**City of Portland, Maine – Building or Use Permit Application** 389 Congress Street, 04101, Tel: (207) 874-8703, FAX: 874-8716

Location of Construction: 115 W. Commonwealth Dr		Owner: Drouin, Waltraud Hildegard		Phone:	
Owner Address: SAA Ptld, ME 04103		Lessee/Buyer's Name:		Phone:	
Contractor Name: Richard Drouin		Address: 797-6312		Phone:	
Past Use: 1-fam		Proposed Use: Same w/garage		COST OF WORK: \$ 4,000.00	
				PERMIT FEE: \$ 40.00	
				FIRE DEPT. <input type="checkbox"/> Approved <input type="checkbox"/> Denied	
				INSPECTION: Use Group: Type:	
				Signature: Signature:	
Proposed Project Description: Construct Detached Garage (20 x 24)		PEDESTRIAN ACTIVITIES DISTRICT (P.A.D.) Action: Approved <input type="checkbox"/> Approved with Conditions: <input type="checkbox"/> Denied <input type="checkbox"/>			
Permit Taken By: Mary Gresik		Date Applied For: 30 September 1997

# BUILDING PERMIT REPORT

DATE: 8 Oct, 97 ADDRESS: 115 W. Commonwealth DR  
REASON FOR PERMIT: To Construct a detached garage  
BUILDING OWNER: Richard Drouin  
CONTRACTOR: owner  
PERMIT APPLICANT: ↑ APPROVAL: \*1, \*2, \*26, \*28, \*30 **DENIED**  
USE GROUP U BOCA 1996 CONSTRUCTION TYPE B-B

SECTION DETAIL

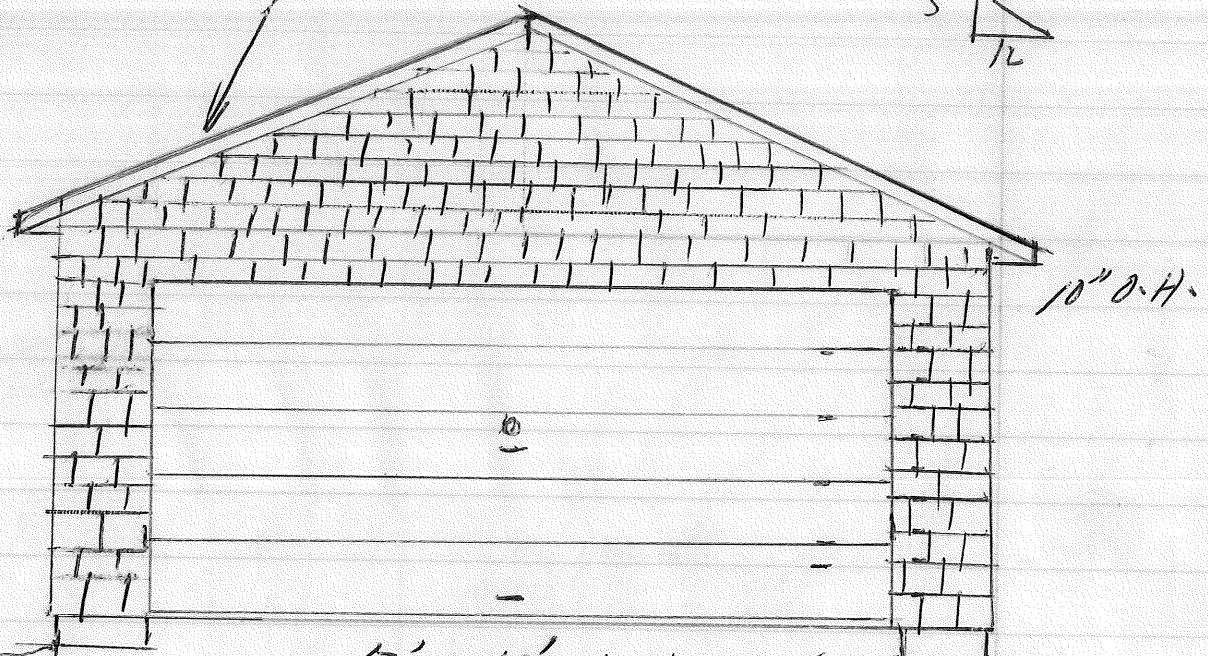
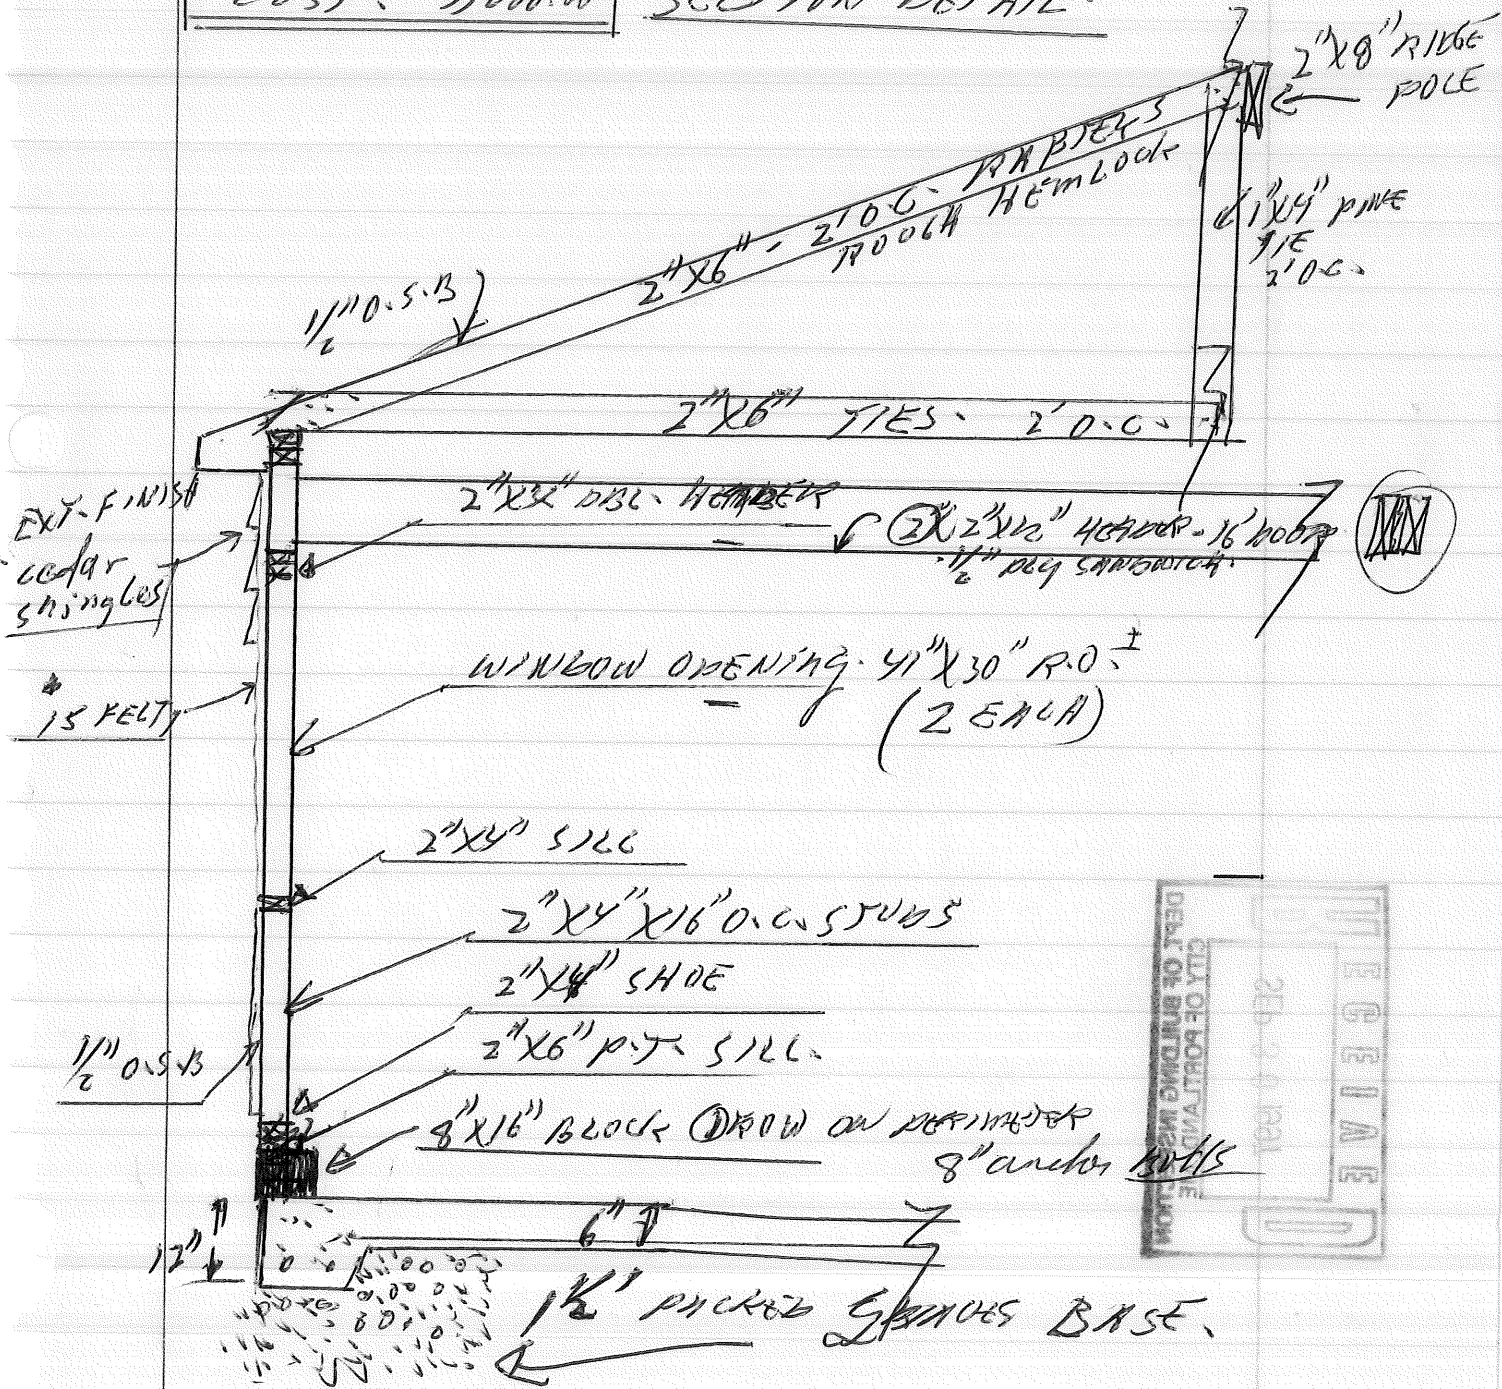
- 30. *The proposed 2x6" rafters @ 2'oc, does not meet The City's building code - A minimum of 2x8" @ 16" OC must be used*
- 31. \_\_\_\_\_
- 32. \_\_\_\_\_

FRONT

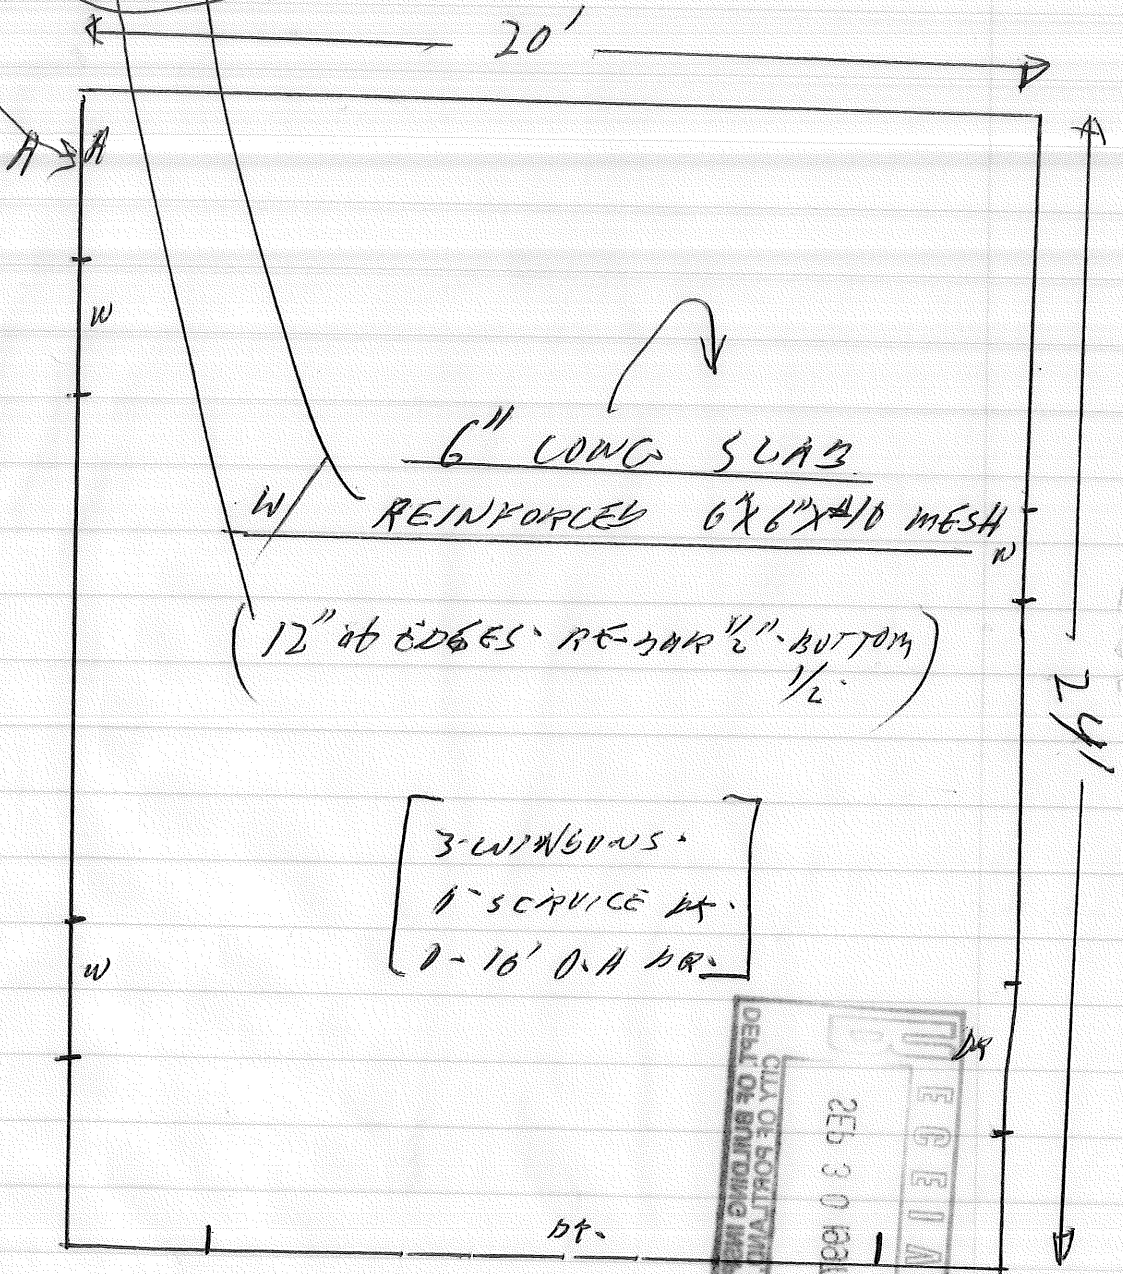
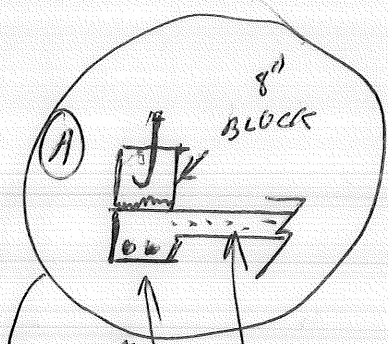
Normally 25' req in R-3 Zone  
20' min Allowed using Section  
14-433
